ANALYSIS

**EXHIBIT A
DEPARTMENT REVIEWS**

General RV Site Plan Amendment

14295 S. Minuteman Drive

**EXHIBIT F
SITE PLAN**

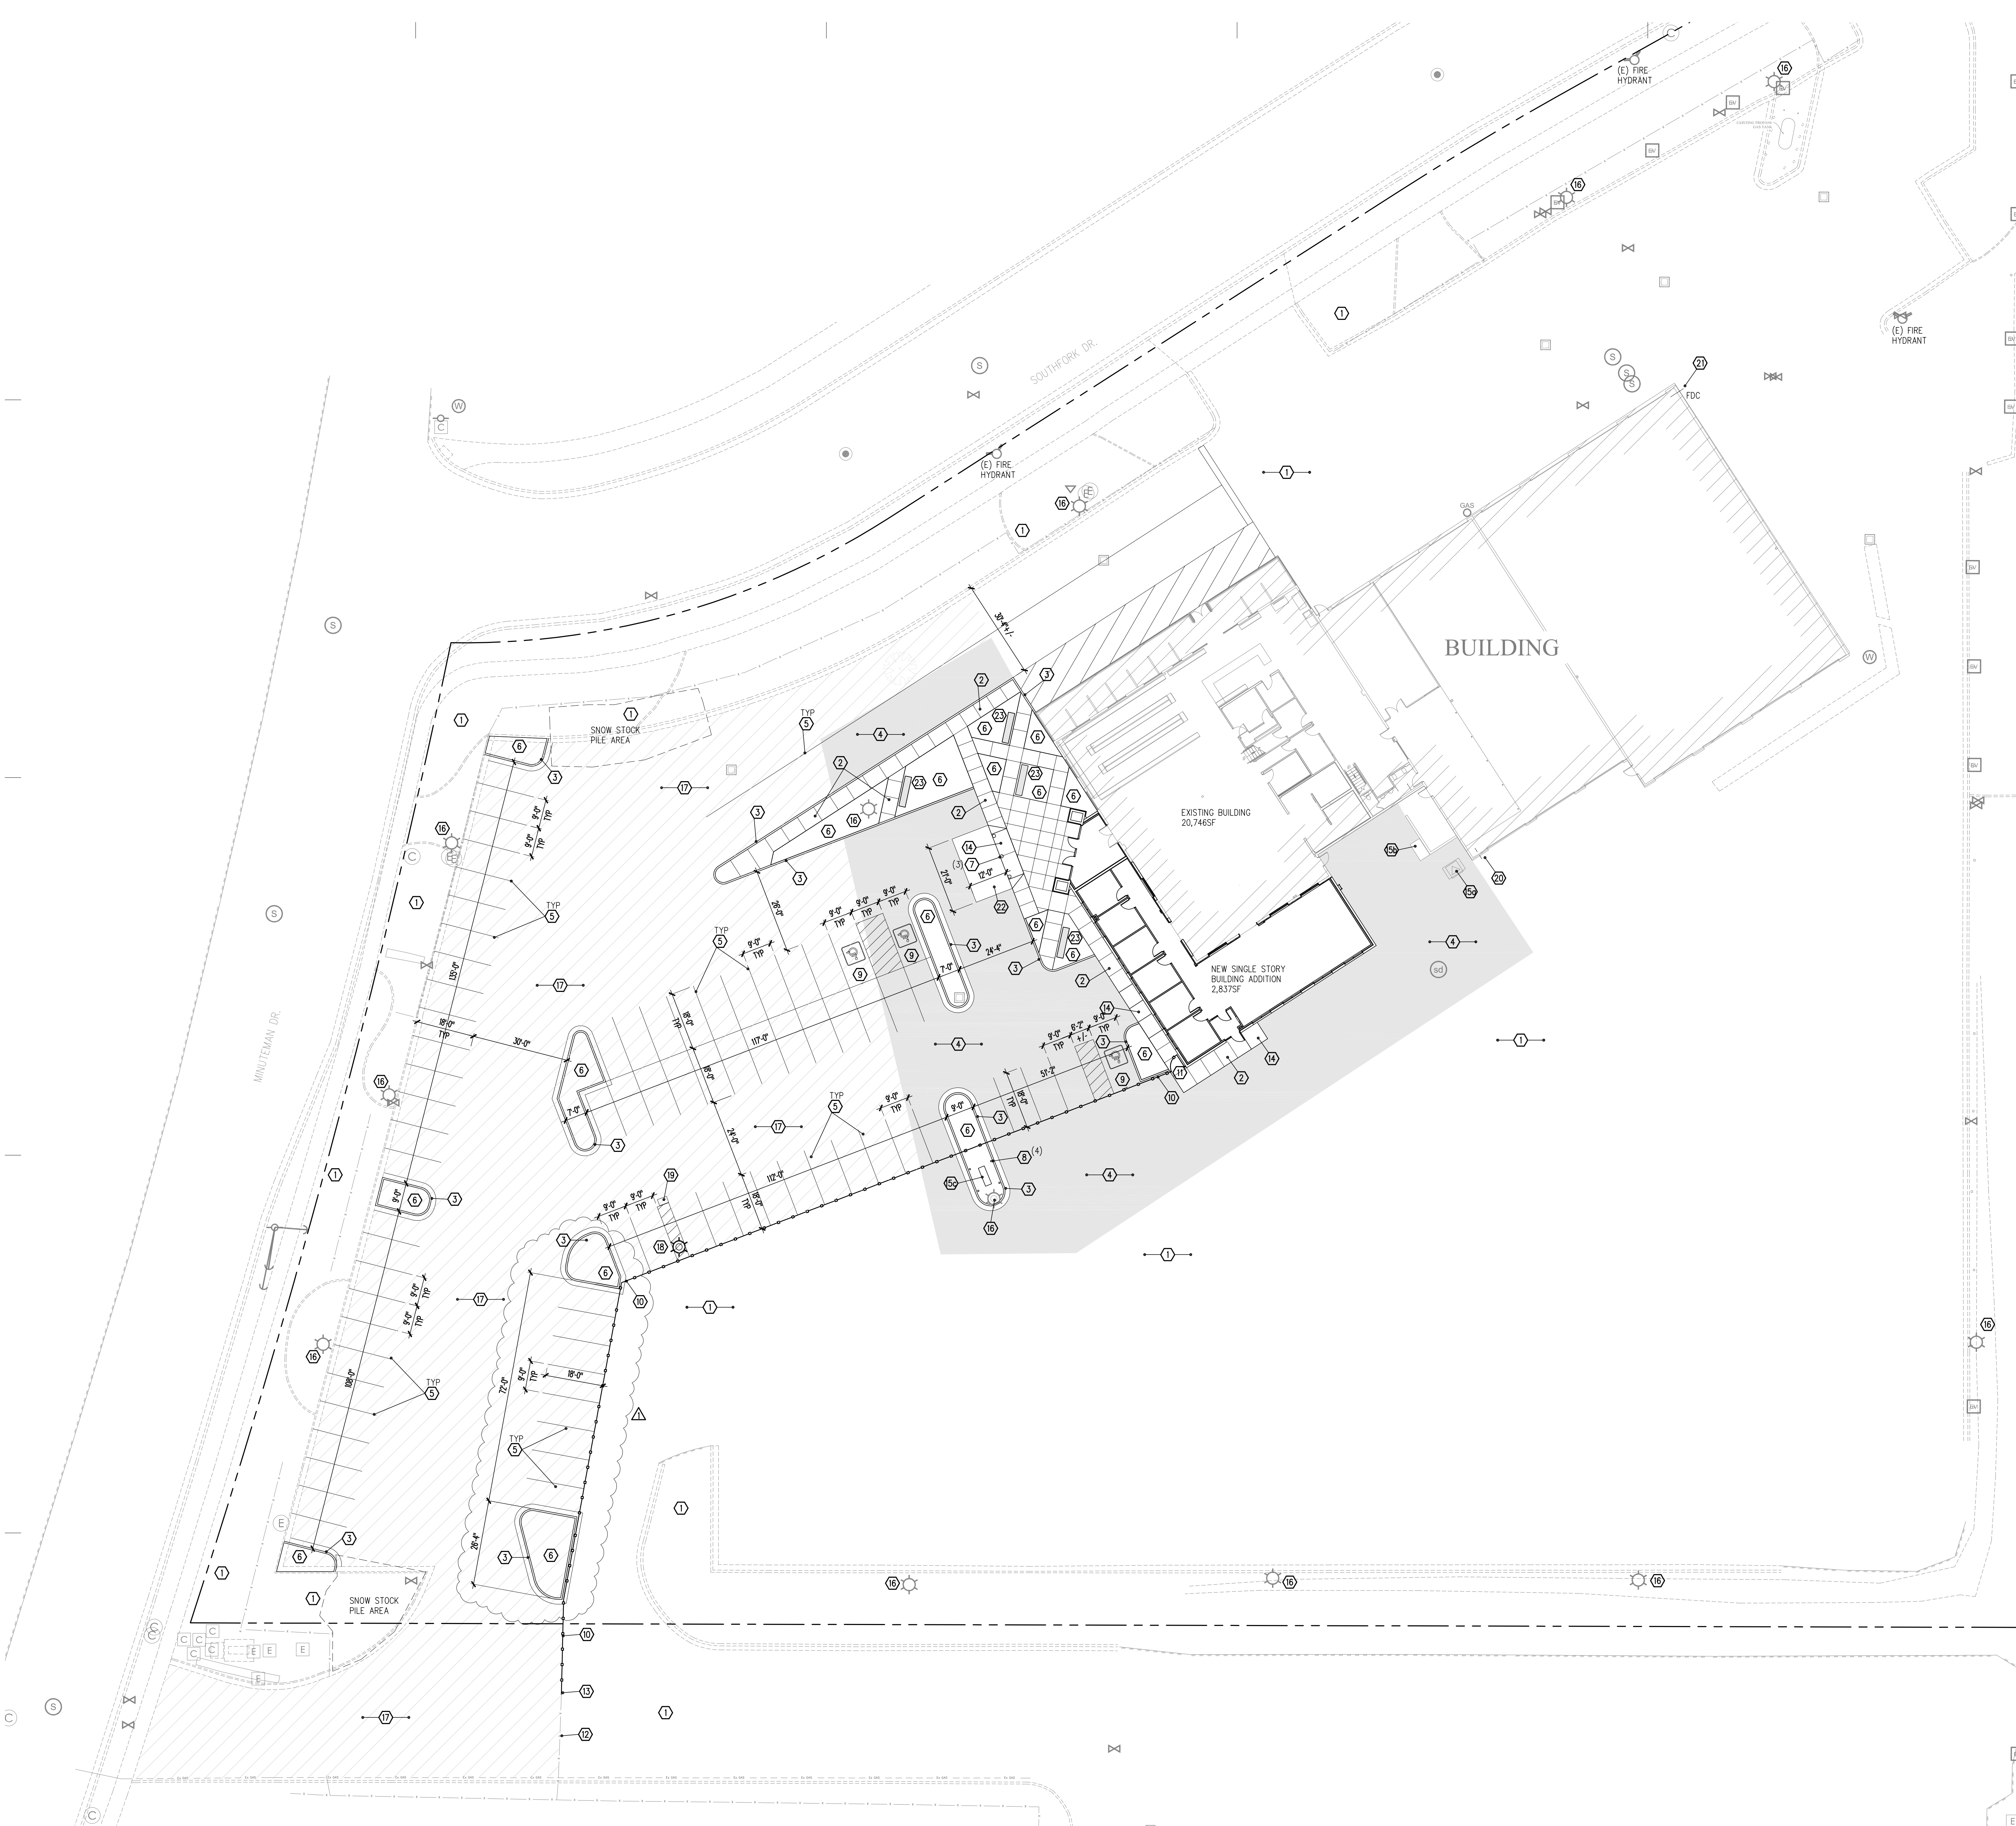
Site Plan Layout. The Site Plan (Exhibit F) shows that the one-story, 2,837 ft² building addition will be located to the west and south of the existing two-story building, towards the center of the parcel. It is located approximately 105 feet from the nearest exterior parcel line,

exceeding all setback requirements. The building addition impacts some of the existing parking. Parking and landscaping modifications occur to the west of the addition, and are discussed in subsequent sections of this staff report.

Parking. The Site Plan (Exhibit F) shows that the parking lot will be modified near the entry of the building, and new parking will be added along the western portion of the parking lot adjacent to Minuteman Drive. The RV sales and service uses on the site will require 84 parking stalls to be provided. The modified parking lot will contain 76 stalls, which is within the ten percent (10%) natural adjustment range of 76-93 allowed.
